**Economic Commission for Europe****Inland Transport Committee****World Forum for Harmonization of Vehicle Regulations****159<sup>th</sup> session**

Geneva, 12-15 March 2013

**1958 Agreement – Consideration of draft amendments  
to existing Regulations submitted by GRE****Proposal for Supplement 22 to the 02 series of amendments  
to Regulation No. 7 (Position, stop and end-outline lamps)****Submitted by the Working Party on Lighting and Light Signalling \***

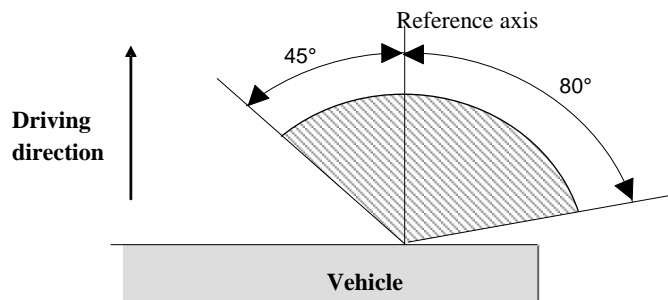
Paragraphs 6.2.4. and 6.2.4.1., amend to read:

"6.2.4. Moreover,

6.2.4.1. Throughout the fields defined in the diagrams in Annex 1, the luminous intensity of the light emitted must be not less than 0.05 cd for front and rear position lamps and end-outline marker lamps, not less than 0.3 cd for devices of categories S1, S3 and for those of categories S2 and S4 by day; it shall not be less than 0.07 cd for devices of categories S2 and S4 by night;"

Front position lamps.

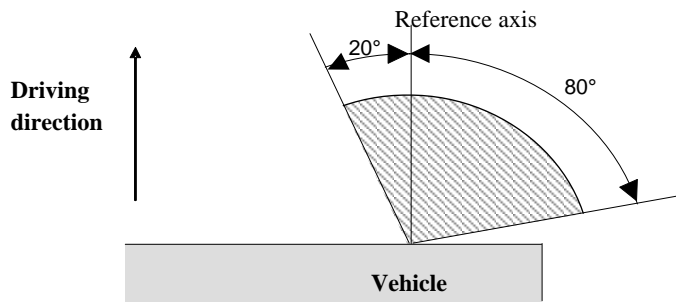
Annex 1, amend to read:

In all cases, the minimum vertical angles of light distribution in space are 15° above and 15° below the horizontal for all categories of devices included in this Regulation, except:

- (a) For lamps intended to be installed with their H plane at a mounting height less than 750 mm above the ground, for which they are 15° above and 5° below the horizontal;
- (b) Optional lamps intended to be installed with their H plane at a mounting height more than 2100 mm above the ground, for which they are 5° above and 15° below the horizontal;
- (c) For category S3 or S4 stop lamp for which they are 10° above and 5° below the horizontal."

Under the H plane for front position lamps intended to be installed with this plane at a mounting height less than 750 mm above ground.

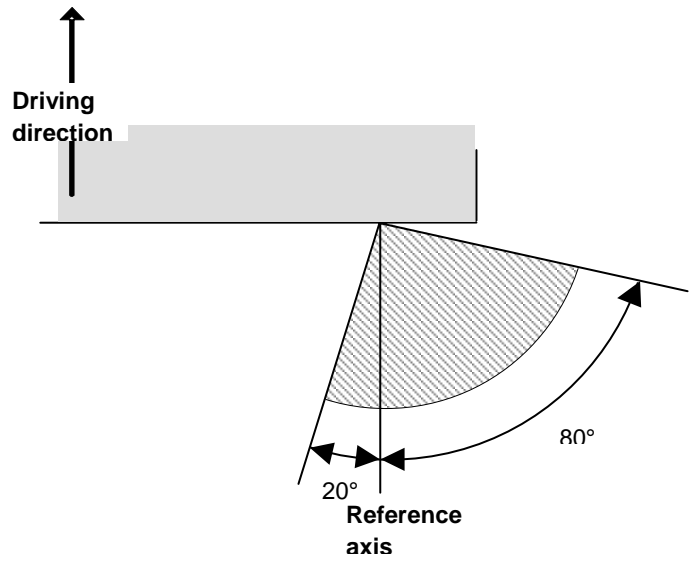
Under the H plane for rear position lamps intended to be installed with this plane at a mounting height less than 750 mm above ground.
